#### **Recall Bulletin**

**Recall No. 20V-448**

### **Xtreme Outdoors**

This recall bulletin is to inform the retail customer of a difference in weight for the Mini Max model.

# **Incorrect VIN Sticker**

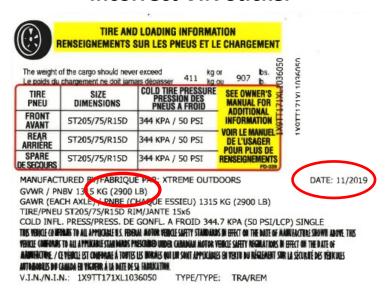
This is a VIN sticker with the incorrect weight rating. You will need to locate the VIN sticker at the front driver side of the camper.

Apply heat to the VIN sticker, peel and pull to remove. Clean the surface where the incorrect VIN sticker is removed. (careful not to cause damages to the wall)

The Production date is listed on the VIN sticker as well. Check this date to confirm affected vehicles produced 07/19 –06/20
